RE: Response to Comments Letter for Permit Application PRCCP20251408

The purpose of this letter is to provide satisfactory answers to the comments/questions issued in a comment letter dated January 21, 2026. The answers are listed below in bold and are preceded by the comments/questions listed in the original letter.

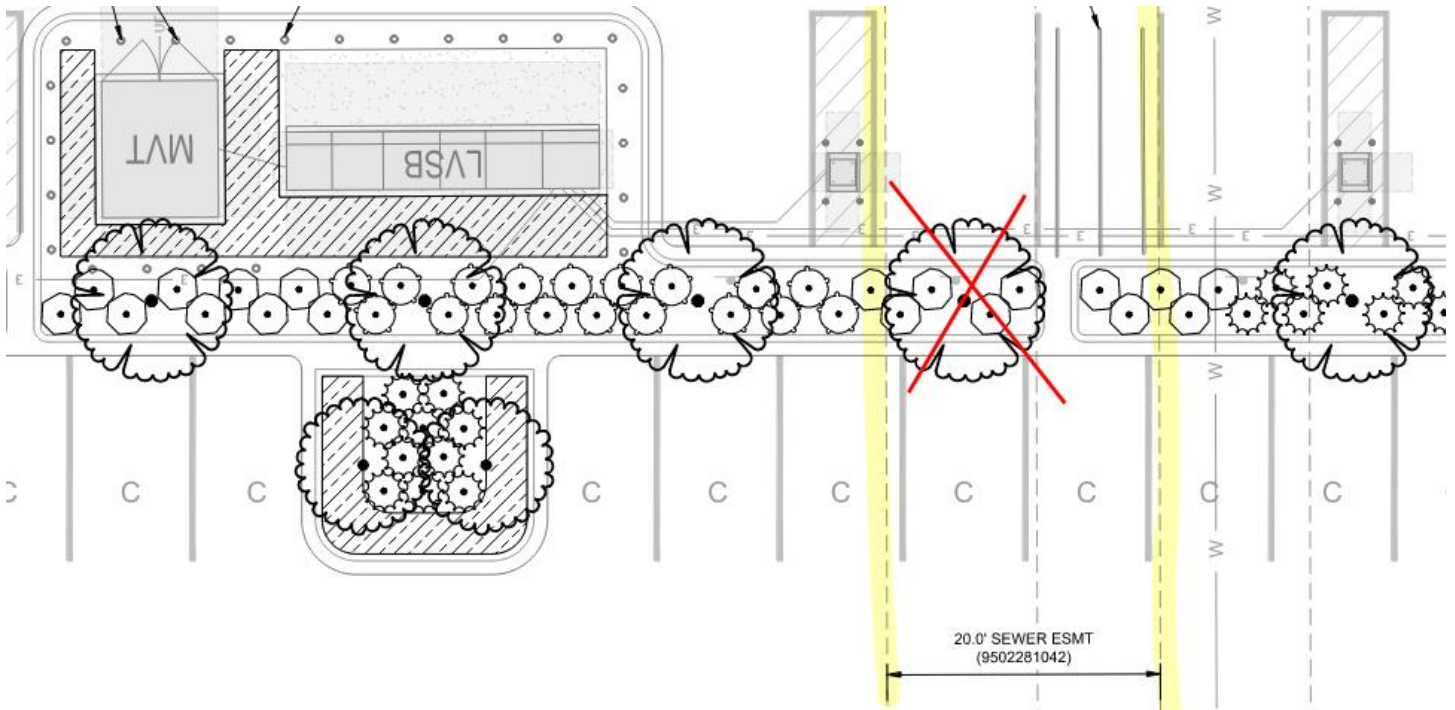
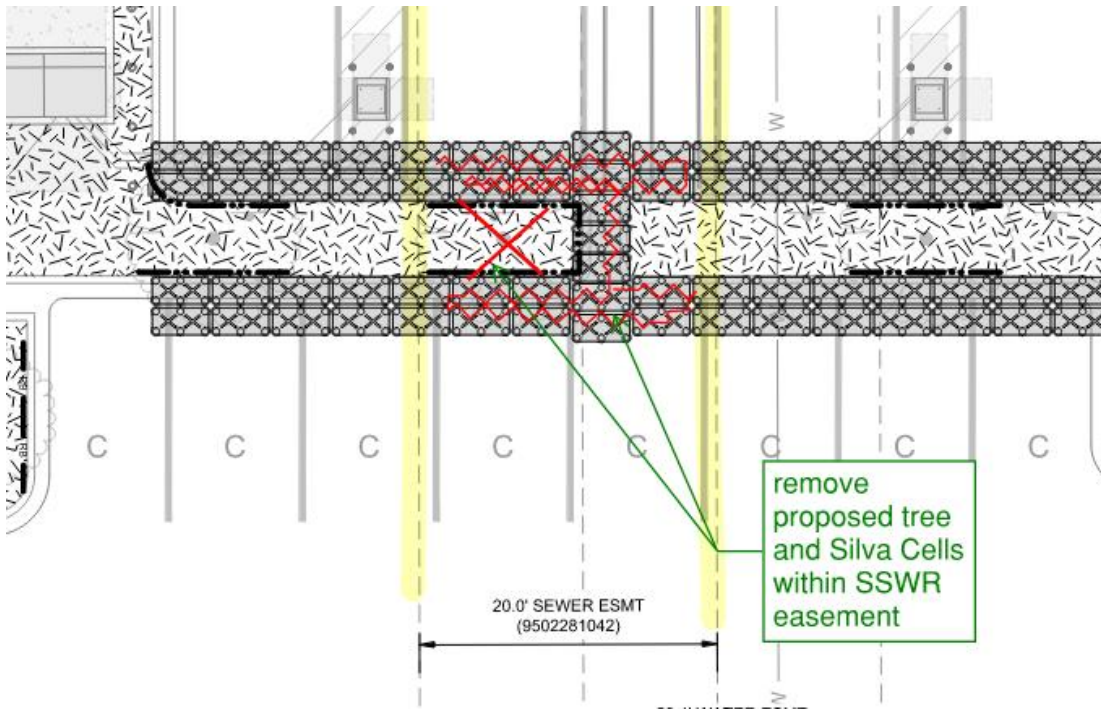
[@Jillian Hulse-Lew](#), can you confirm that you would accept not having trees and silva cells in that area since the engineering department prohibits it? Snips below for reference. Note, we have coordinated and got confirmation with Fruitland Mutual Water Company regarding silva cells in their easement. Let me know if you have any questions.

There is a lot of history with this easement and the sewer in this area, but in order to answer your immediate question, the trees and the silva cells should not be in the easement. Yes, landscape is allowed in easements, but tree roots are a huge problem for sewer and the silva cell is in itself a structure.

There is a pipe down there, but the plans do not show it. This isn't surprising as it is not shown in our GIS either.

Planning would accept excluding structural soil cells and trees from the area impacted by the easement. However, you will still need to keep the landscaping island and incorporate shrubbery in place of the tree.

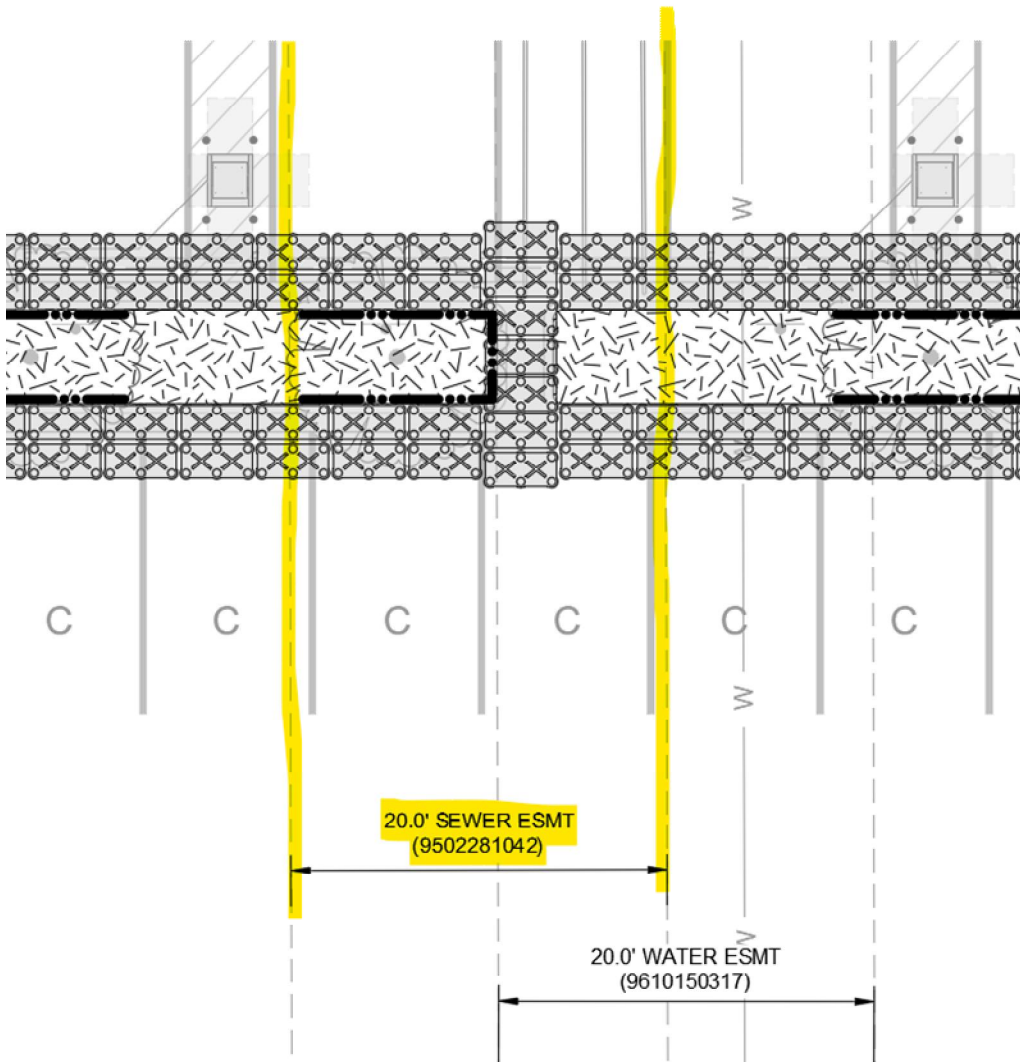
The Puyallup Walmart EV project has received Civil and Building permit review comments to install Silva Cells within the new parking internal connector strip landscape islands. The silva cell system is an underground grid that helps maintain the tree roots from impacting utilities and pavement (see image below).

Can you please confirm that the silva cell system is permitted to be installed within the existing 20' City of Puyallup sanitary sewer easement? Please feel free to reach out with any questions and I will be happy to assist you.

②0 EASEMENT, INCLUDING TERMS AND PROVISIONS CONTAINED THEREIN:
RECORDING INFORMATION : 9610150317
IN FAVOR OF : FRUITLAND MUTUAL WATER COMPANY
FOR : WATER LINE

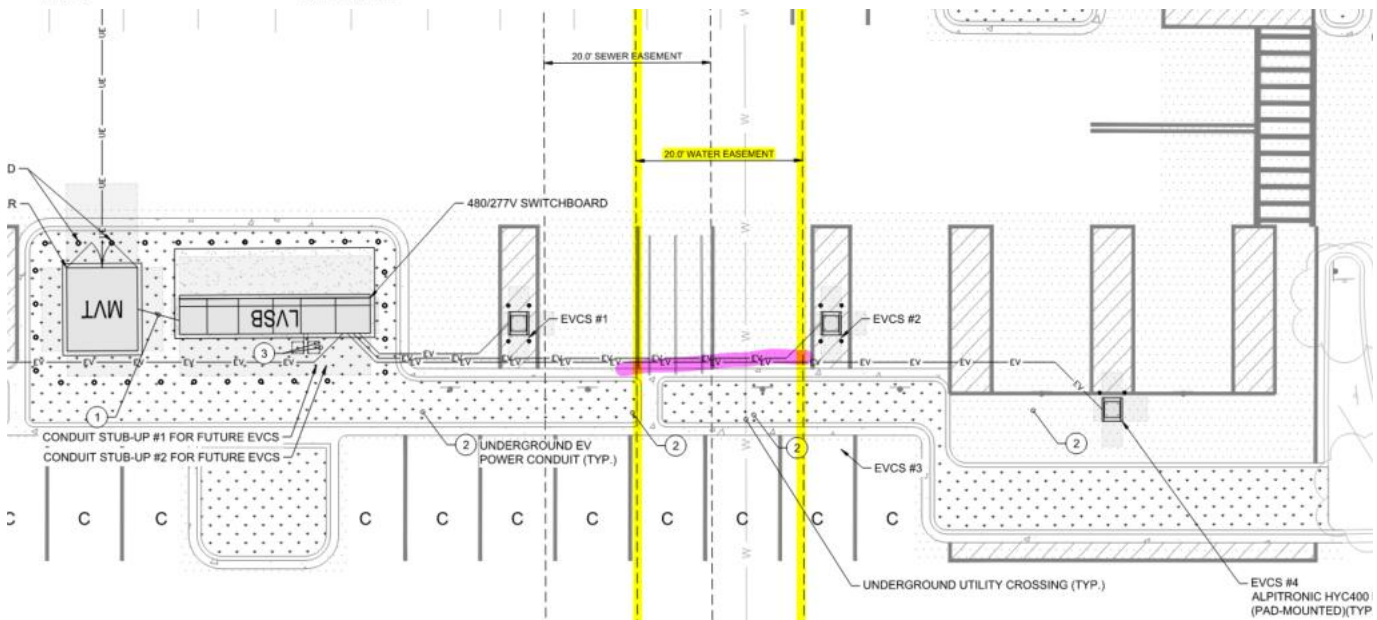
Our plans show proposed electrical conduit crossing Fruitland Mutual Water Company's existing 20' waterline easement (9610150317). See snip below. Could you please confirm that installing the electrical conduit within this easement is permitted?

It is ok to cross our easement and our water main. Fruitland does want a foot of separation either over or under and no direct bury power lines. Our mains in that area are ductile iron and we don't want to take any chances of lost current.
